Four H Fashions Ltd.

16th February 2021

Buildings Information

Extended slab (marked as yellow)

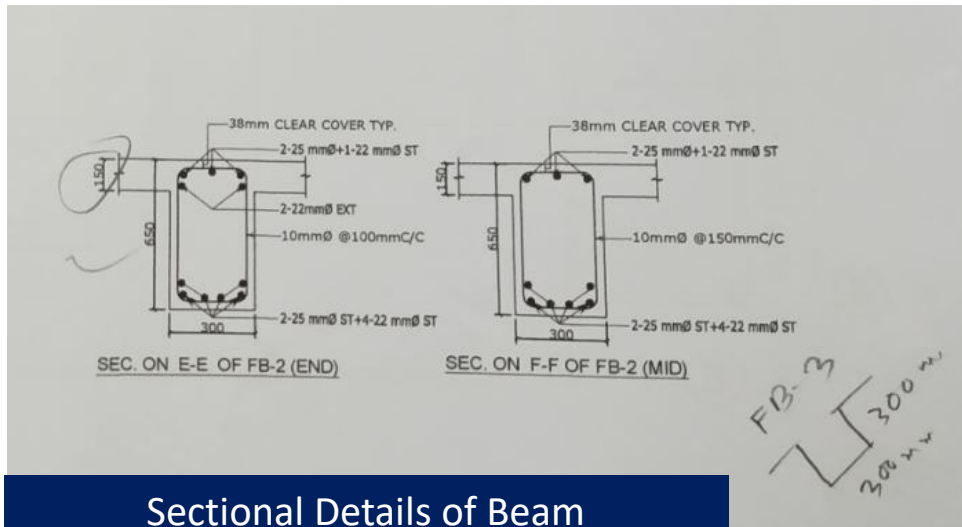
Lack of information and discrepancies in as-built drawings

The slab of Utility Building extended to the boundary wall at North-west corner. Which is not mentioned in the drawings. Also, the down stand of the beam were found 300 mm instead of 400 mm at security portion of the building.

300 mm down stand

Item No.	Observation	Recommended Action Plan	Recommended Timeline
01	Lack of information and discrepancies in as-built drawings (Utility Building).	Building Engineer is to survey the whole structure and update as-built drawings representing accurate site condition.	6-weeks
02	Absence of design documents (Utility Building).	Factory engineer is required to prepare the design documents including a design report, and a set of structural drawings in compliance with section 1.9.1.1 and section 1.9.1.2 as per BNBC part 6 and submit to RSC for review.	6-weeks
03	Absence of design documents (Utility Building).	Carry out remedial works (if any) after review by RSC.	6-months
04	Undocumented external steel stair, apparently inadequate connection.	The building engineer to check the structure, collect information and produce accurate as-built structural documentations.	6-weeks

Observation: Utility Building

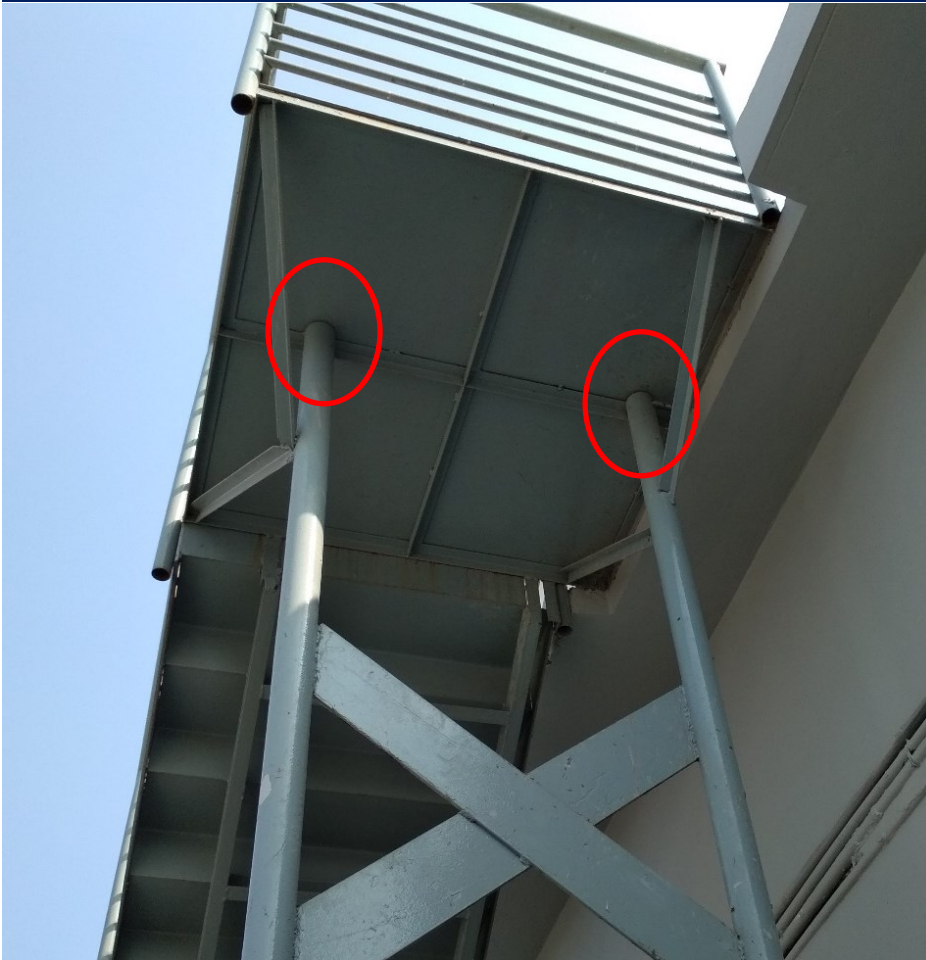
Absence of design documents

As per BNBC, every building or structure designed shall have its design documents prepared in accordance with the provision of Section 1.9.1. The design document shall include a design report, and a set of structural drawings, which shall be prepared in compliance with section 1.9.1.1 and section 1.9.1.2 as per BNBC. At the time of inspection, only as-built drawing, load plan and geotechnical report were available, but no design report was available which is required to be prepared in compliance with section 1.9.1.1 (part-6, BNBC).

External Steel Stair

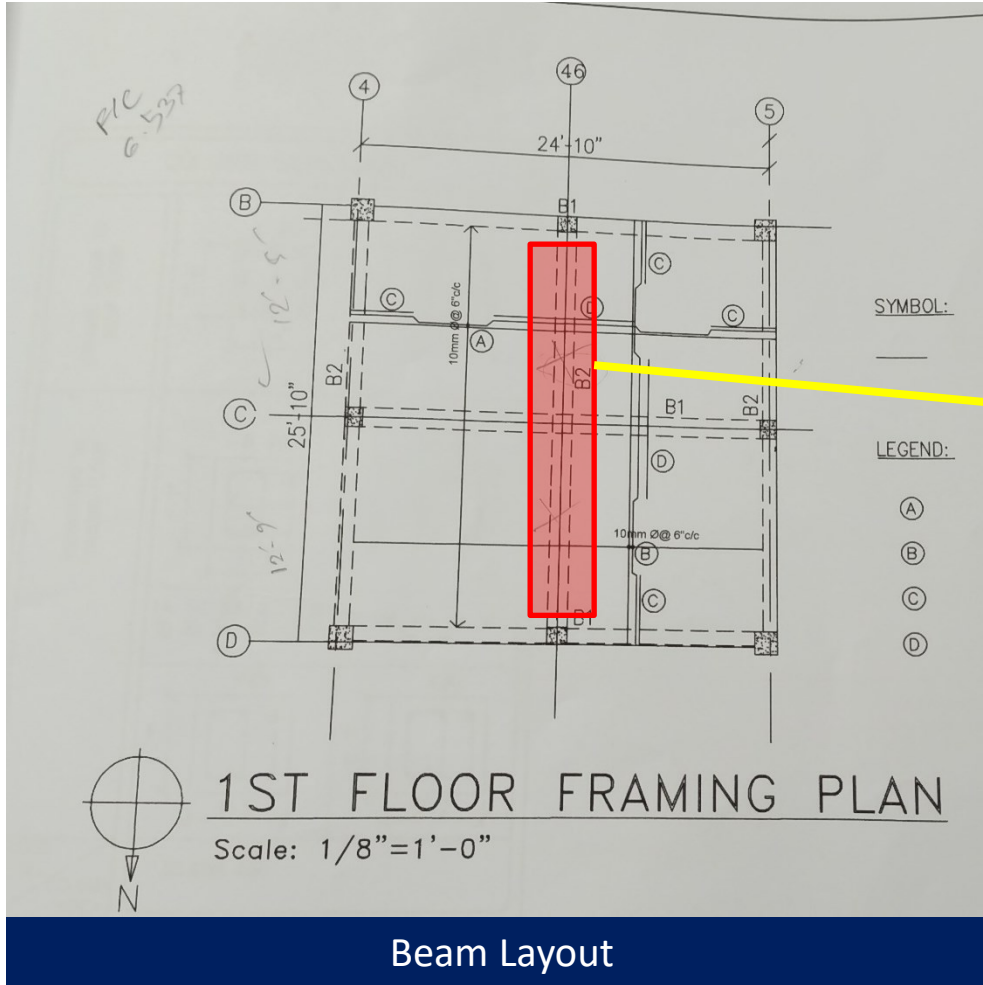
**Undocumented external steel stair,
apparently inadequate connection.**

Apparently inadequate member and poor connection was observed at external steel stair of Utility Building

Poor Connection

Undocumented steel stair was found at North side of the building.

Item No.	Observation	Recommended Action Plan	Recommended Timeline
05	Undocumented external steel stair, apparently inadequate connection.	Factory engineer is required to carry out member adequacy, connection adequacy & lateral stability check of the steel stair.	6-weeks
06	Undocumented external steel stair, apparently inadequate connection.	Implement remediation work where necessary.	6-months
07	Discrepancies in as-built drawings (Fire Pump Room).	Building Engineer is to survey the whole structure and update as-built drawings representing accurate site condition.	6-weeks
